## South Parade Pier Premises Licence Application Acoustic Report

Richard Maidment MSc BSc MIOA  
Environmental Health Service

Date of Report: 7<sup>th</sup> June 2017

- 2.1. This section is a review of the report titled "Noise Breakout Testing Report for South Parade Pier Ltd" compiled by Airtight & Noisecheck Limited, dated 25-26<sup>th</sup> April 2017.

Graph 1

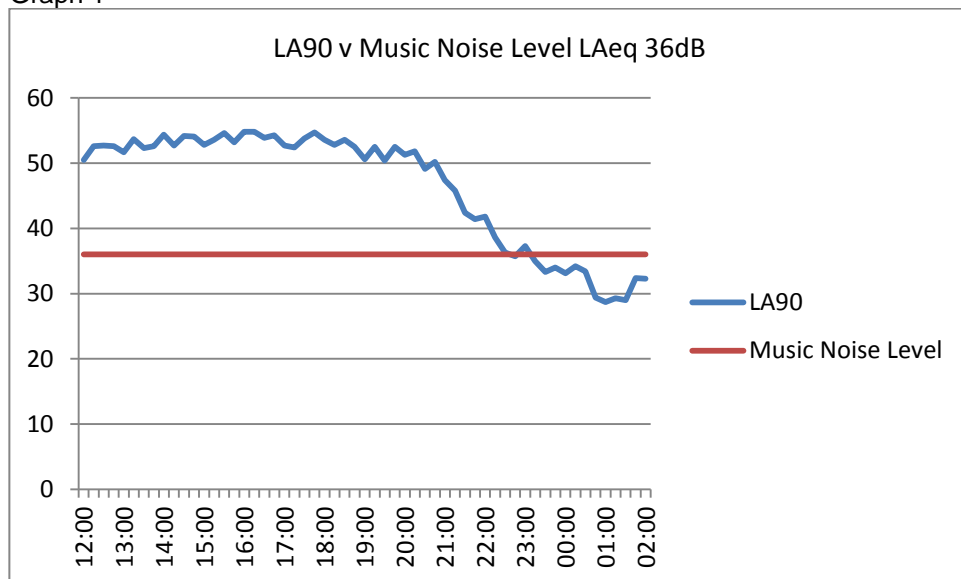
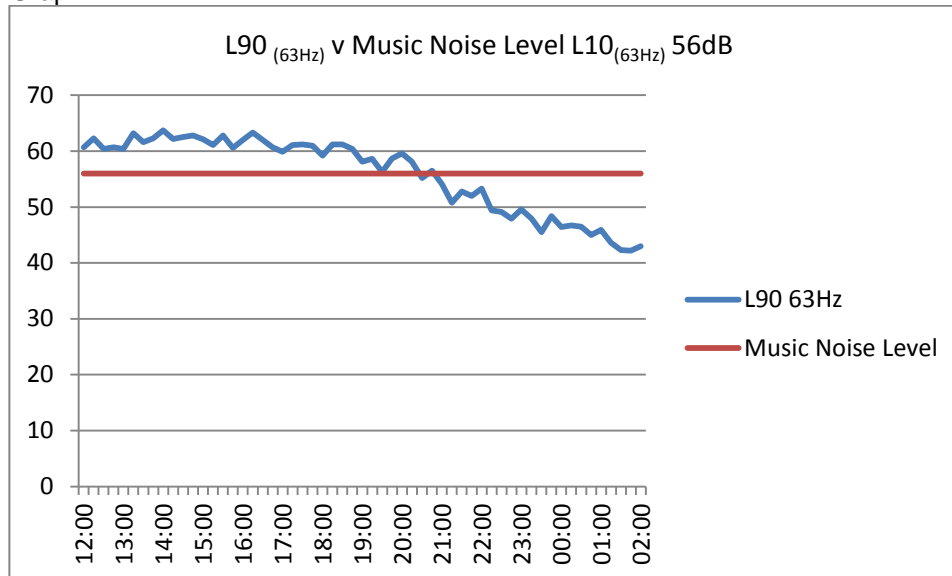
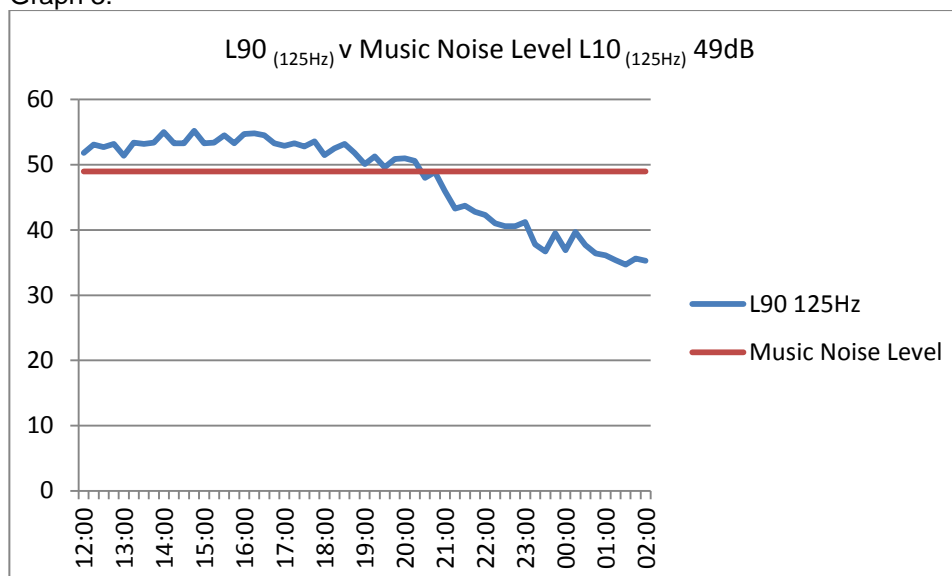
4.2. Plotting the music noise level against the measured background over time indicates that the impact from the venue in terms of bass breakout is likely to be noticeable from around 21:00hrs and the broad band level from around 23:00hrs. See Graphs 1-3.

- 5.5. Plotting the predicted music noise level against the measured background over time demonstrates that the impact from the venue in terms of bass breakout is likely to be noticeable from around 21:00hrs and the broad band level from around 23:00hrs, with the impact increasing steadily as the evening progresses. The impact between midnight and 02:00hrs being highly significant.

- 5.7. This service continues to maintain its position that the provision of regulated entertainment should be restricted to 23:00hrs as allowed by The Live Music Act or music noise levels reduced commensurate with the sound insulation of the structure, which will require levels to be tightly controlled to a maximum of 89dB in the 63Hz and 125Hz octave bands.

**Appendix 1: Roof Construction.**

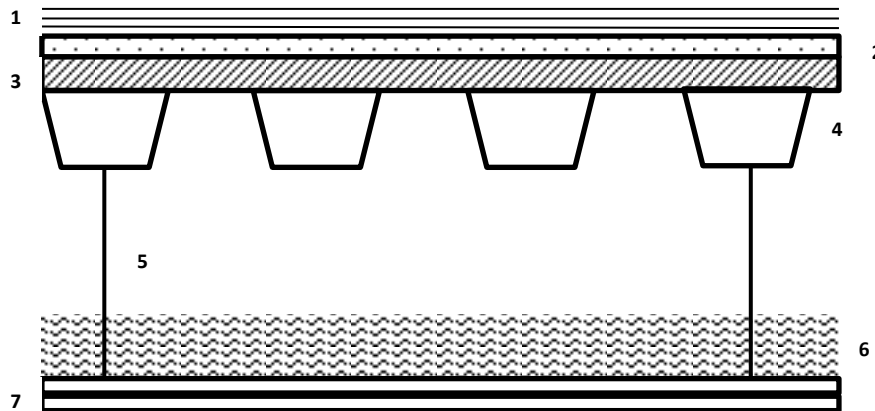
- 2.19. The Table in paragraph 8.1 also states that the anticipated sound reduction of the ceiling / Roof of the venue is greater than 55dB(A) so can be ignored from the calculation but there is no explanation as to how this figure has been derived.

- 2.20. We have used insulation prediction software based upon the mass of the building elements and construction technique which indicates this structure is more likely to have a sound reduction index of  $R_{w+Ctr}$  46dB. See Appendix 1 for detail.

**Appendix 4: Noise Maps**

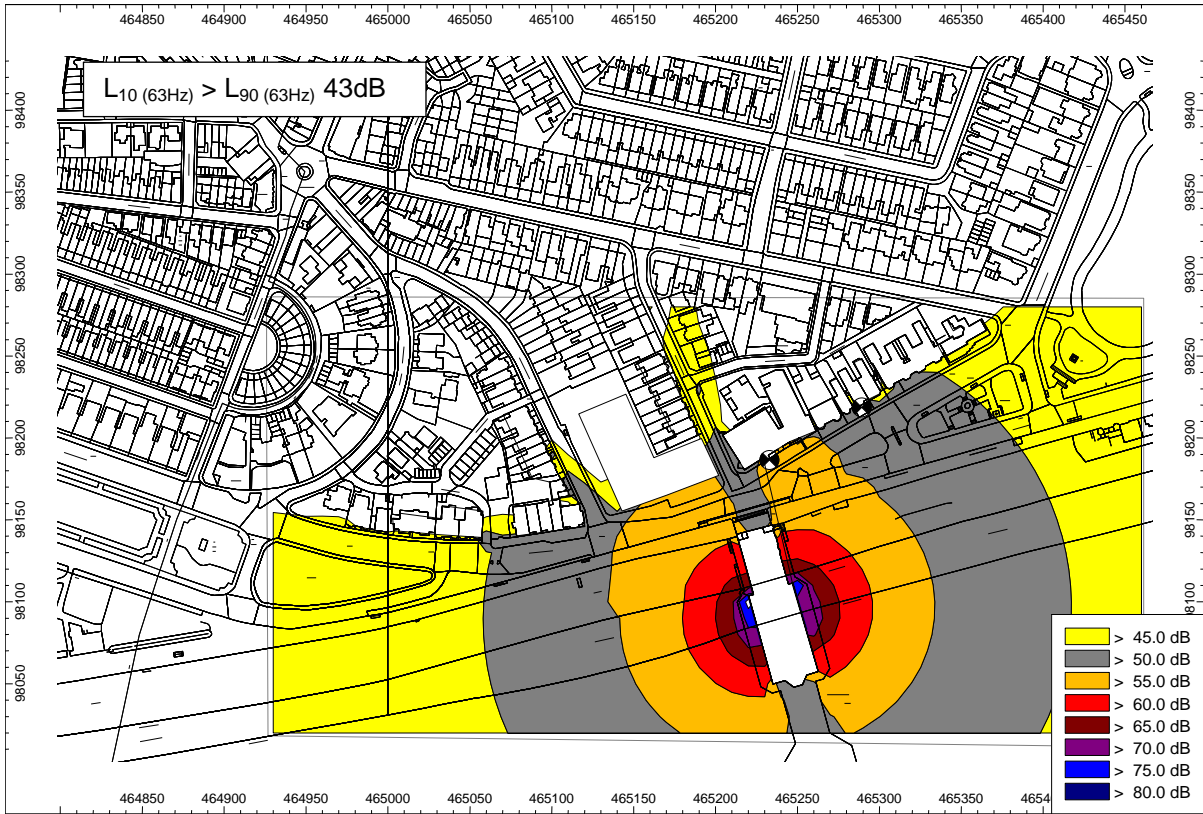
- 5.4. The noise maps in Appendix 4 demonstrate the likely extent of the predicted impacts upon the locality. Whilst disturbance from the broad band noise would be mainly confined to the front façade of The Royal Beach Hotel and the new McCarthy and Stone retirement accommodation, the low frequency bass component of the music is highly likely to affect all properties along South Parade from Alexandra Court Retirement home to St Helens Court.
